**Memorandum**

**Re: West DuPage Recycling and Transfer Station Siting Application – Criterion 2**

Figure 1

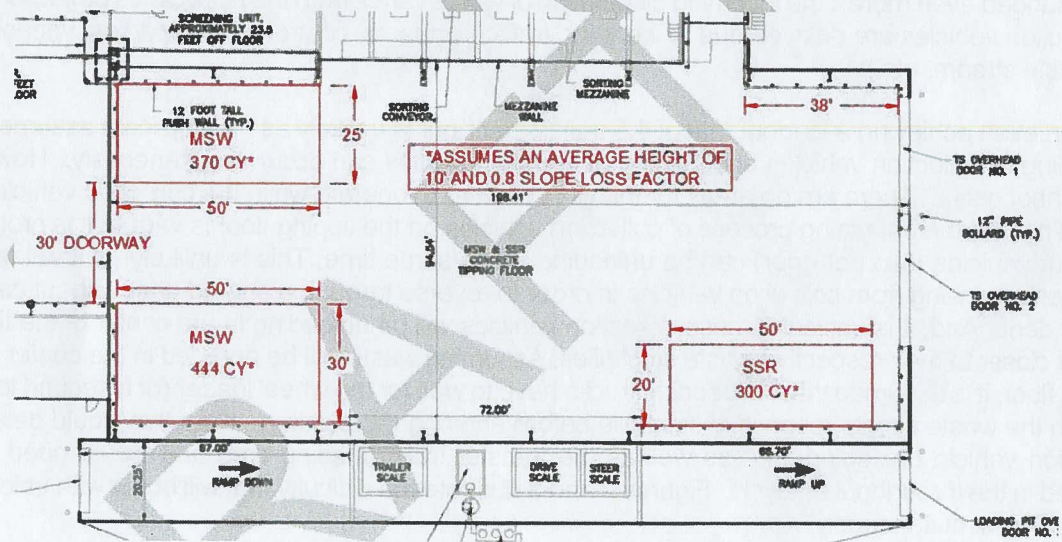
The applicant claims there is approximately 1,333 cubic yards (L90'xW50'xH10'x0.8 slope loss factor) of storage capacity on the tipping floor. However, this volume assumes the stockpiling of material across the doorway area that will connect the C&D building to the proposed transfer building. As opposed to push walls, this overhead door and adjacent wall area is not designed to withstand the forces of a 10-foot high waste stockpile or the horizontal force of a wheel loader driving against it. Further, this is the same overhead door and area that is proposed to be used in order to move any non-recyclable C&D material from the C&D transfer building to the transfer building. And conversely, to move any loads of C&D material that are inadvertently deposited in the transfer building into the C&D building. As shown in Figure 1, keeping the overhead door and pathway between transfer buildings clear reduces the MSW stockpile capacity to approximately 814 cubic yards (about 30% less than stated by the Applicant).

Similarly, the SSR storage capacity is estimated to be 600 cubic yards or 120 tons, but this quantity assumes two equally sized (L50' x W20' x H10' x 0.8 slope loss factor) stockpiles on the east side of the MSW transfer building. As shown in the figure above, there is clearly not enough room in the northeast corner of the MSW transfer building for a stockpile of this size without blocking the end waste area or overhead door no. 1. In fact, there is virtually no space at all to stockpile anything in that corner without blocking overhead door no. 1. This leaves a single 300 cubic yard or 60 ton stockpile in the southeast corner of the MSW transfer building for SSR storage.

Figure 2

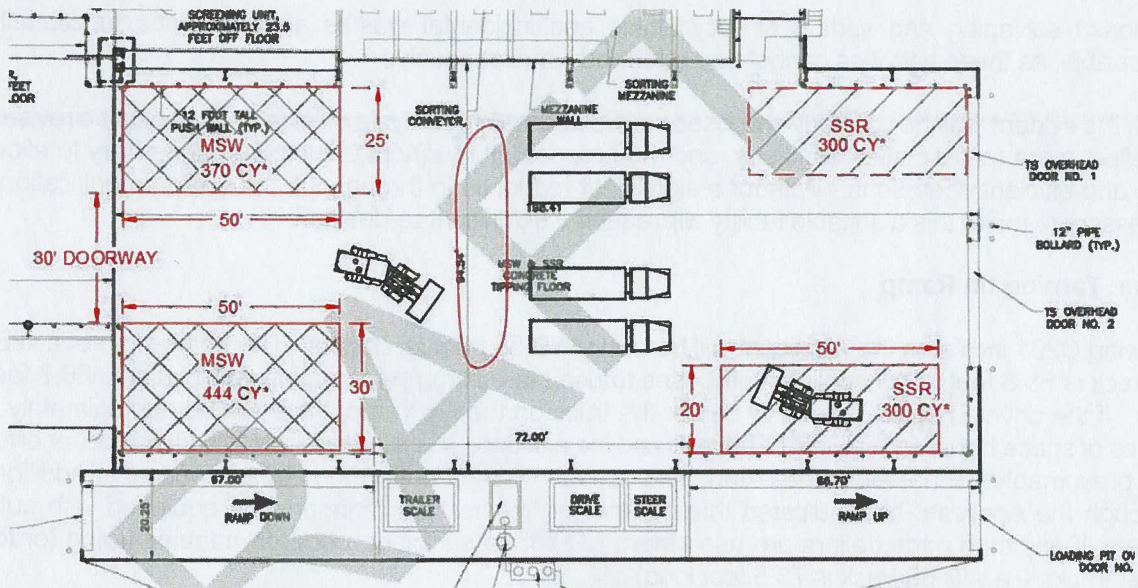
Further, even achieving a loadout rate of 4.5 trailers per hour is unlikely as the applicant assumes that unloading of collection vehicles and loading of transfer vehicles can occur simultaneously. However, this cannot occur. There are no areas for the wheel loader to operate while the collection vehicles are unloading and the unloading process of collection vehicles on the tipping floor is vague. It is proposed that four vehicles (two per door) can be unloading at the same time. This is unlikely as it will require near perfect driving from collection vehicles in order to reverse through a shared door without causing an accident. And, it is unclear if these collection vehicles will be unloading in the center of the tipping floor or closer to their respective waste stockpiles. Assuming waste will be dumped in the center of the tipping floor, it is assumed that succeeding trucks have to wait for the wheel loader (or a second loader) to push the waste into its respective stockpile before entering the building. If so, this would delay the collection vehicle unloading time as well as the transfer trailer loading time and would need to be included in the throughput analysis. Figures 2 and 3 illustrate the difficulty that will occur with unloading and loading simultaneously.

Figure 2 shows the collection vehicles pulling far enough into the transfer building to unload waste near the stockpile areas, but in doing so, limit the area that the wheel loader can operate. This scenario makes it impossible for the wheel loader to work while waste is being unloaded, therefore resulting in the wheel loader having to operate between each wave of collection vehicles in order to consolidate the waste into its respective stockpile or load the waste into a transfer trailer. This would cause significant delays in the timing of incoming collection vehicles (as well as transfer trailer load-out) and, consequently, effect the proposed facility throughput.

Figure 3

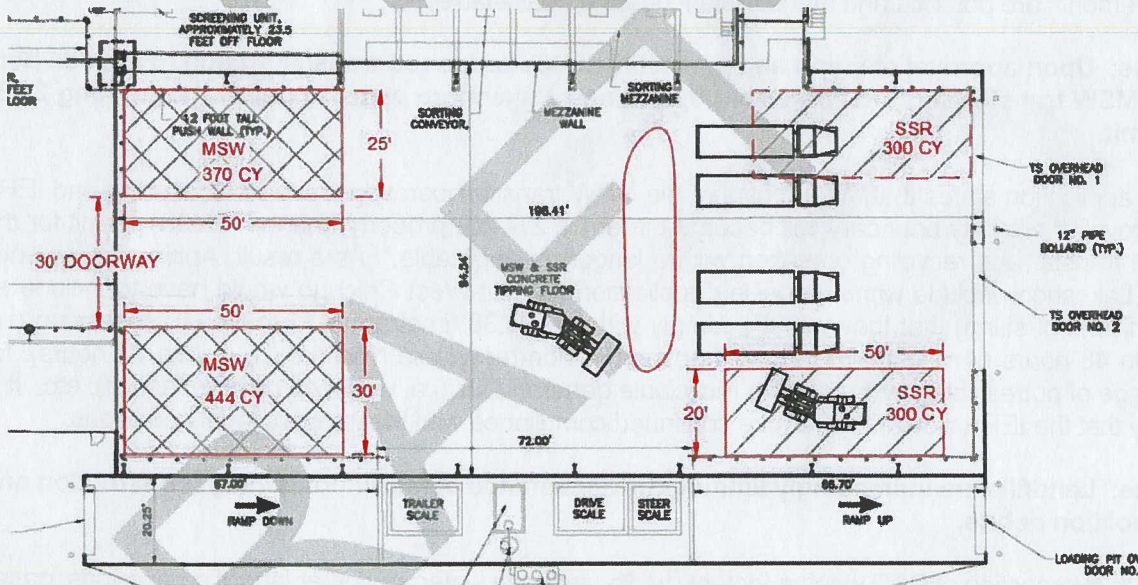
Figure 3 illustrates a scenario where the collection vehicles unload waste closer toward the doors, leaving enough room for the wheel loader to operate behind, but subsequently causing waste to build up and block the recyclable stockpile as well as the transfer building doors. This scenario would likely result in waste being tipped near the overhead doors leaving virtually no room for incoming collection vehicles to pull into the transfer building. Not to mention the inability to close the bay doors and the inherent increased likelihood for litter tracking and unwanted wildlife.
